**NOTICE OF DECISION TO CONSENT TO AMEND A REFERRED PROPOSAL
DURING ASSESSMENT**

Yogi Magnetite Project
Assessment No. 2154

Attachment 1 - Amended proposal content document and figure/s showing the amendments

FIGURE 1

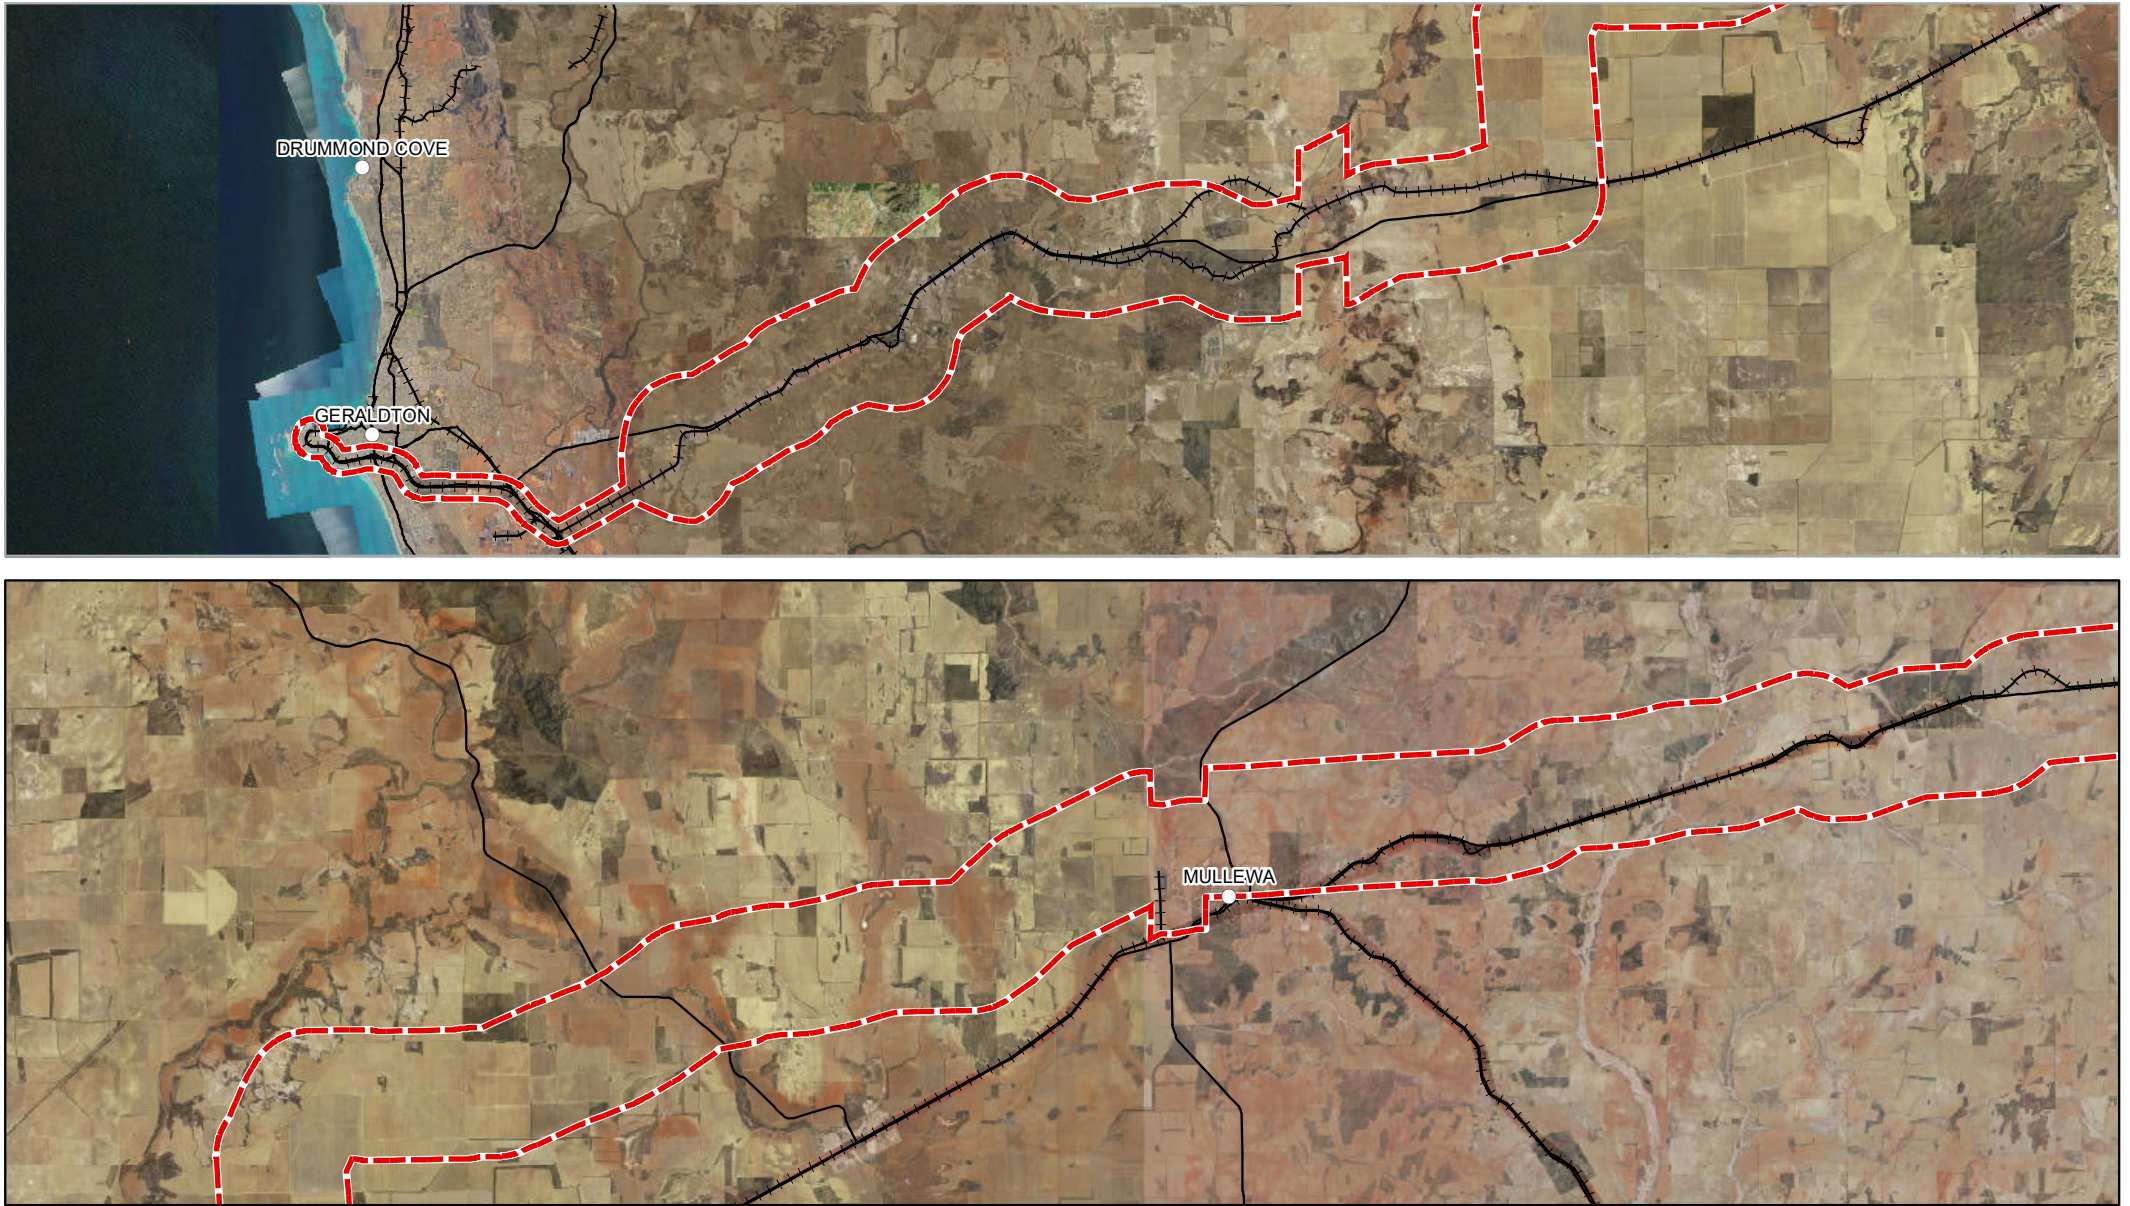
- An increase in power generation capacity from 70 megawatts (MW) to 71.08 MW and a change from thermal (gas) power only to a combination of gas and renewable energy (solar, wind and battery energy storage system).
- Amendment of a clerical error regarding the area of the Pipeline Development Envelope (PDE) which was stated to be 76,800.5 hectares (ha); the actual area of the PDE is 76,439 ha.

Proposal element	Location / description	Proposed extent, capacity or range
Operational elements		
Groundwater abstraction (water demand)	Figure 1	Up to 1 GLpa from the water supply borefield
Mine site dewatering	Figure 1	Up to 4 GLpa from the mine pit dewatering (to be used for processing)
Power	Figure 1	Up to 71.08 MW thermal power station (upper limit for power generation) with variable renewable contributions of: <ul style="list-style-type: none"> Up to 34.2 MW solar Up to 28.5 MW wind Up to 24.5 MW Battery Energy Storage System (BESS) to balance and optimise the energy production mix.
Gas supply	Figure 1	Gas to be supplied to the power station via a buried steel pipeline at a rate of up to 23 TJ/day
Overburden / waste rock	Figure 1	Disposal of up to 800 million tonnes (over the life of the project)
Ore processing waste	Figure 1	Disposal of up to 80 million m ³ of dry processing waste (over the project life)

FIGURE 2-2

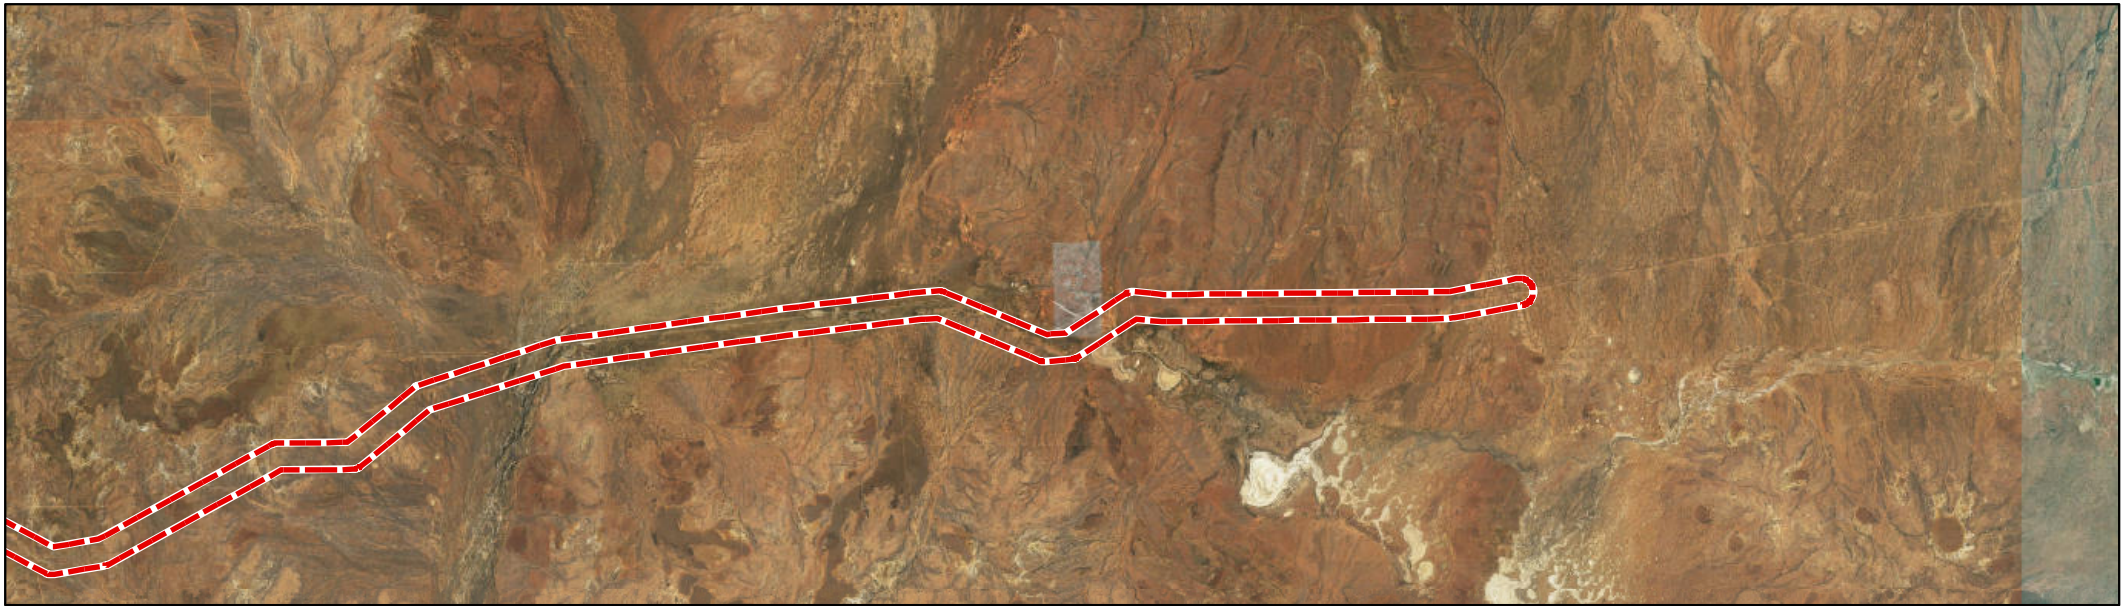
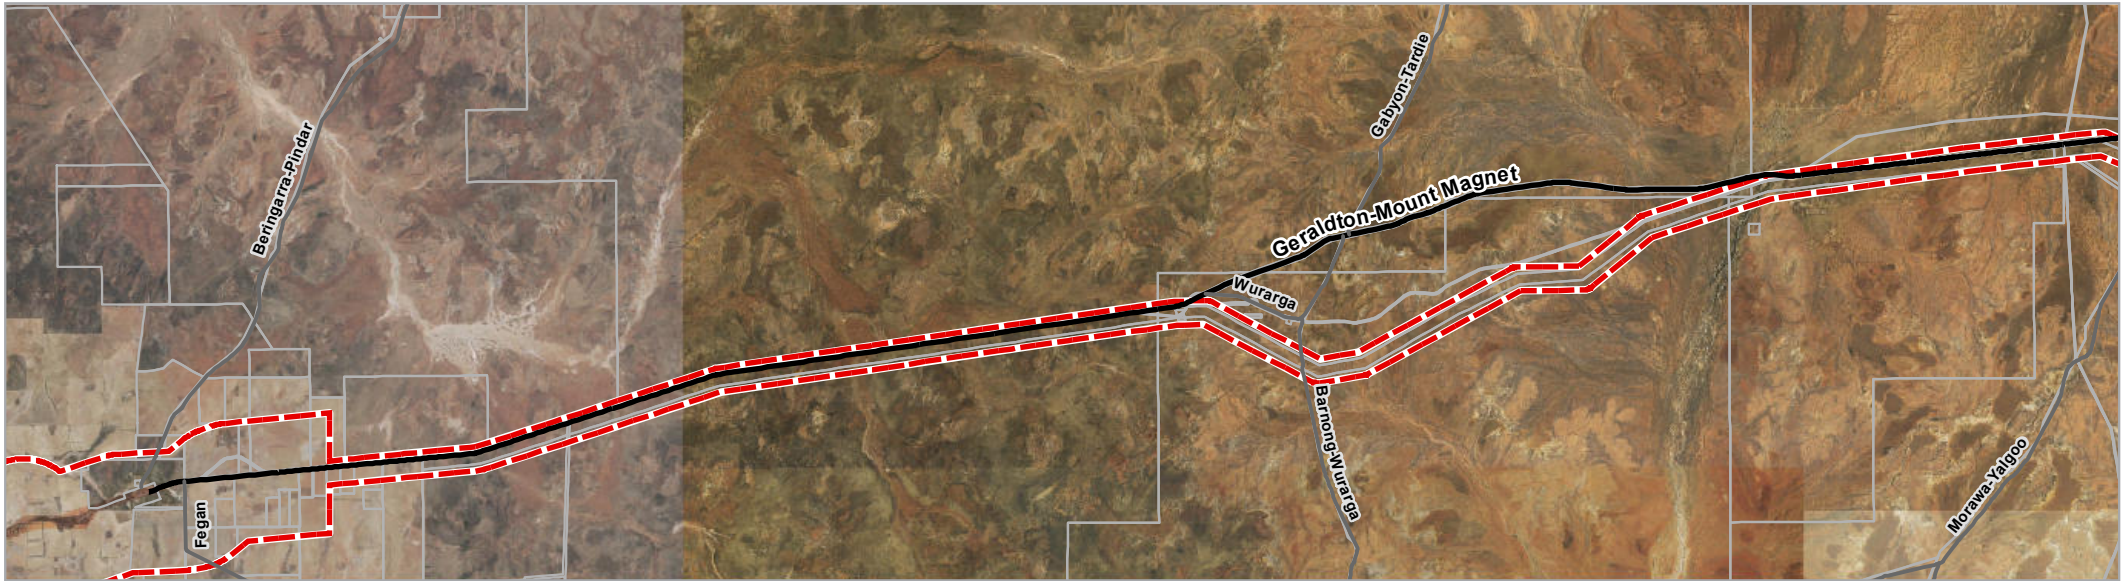
The proposed amendment is to increase the power generation capacity from 70 megawatts (MW) to 71.08 MW and a change from thermal (gas) power only to a combination of gas and renewable energy. Additionally, there was a clerical error regarding the area of the Pipeline Development Envelope (PDE) which was stated to be 76,800.5 hectares (ha); the actual area of the PDE is 76,439 ha.

Proposal element	Original Proposal	s.43A (Amended Proposal)
Physical elements		
Pipeline Development Envelope (PDE) including magnetite slurry pipeline, water pipeline and gas pipeline	Clearing of no more than 200 ha within a 76,800.5 ha Pipeline Development Envelope	Clearing of no more than 200 ha within a 76,439 ha Pipeline Development Envelope
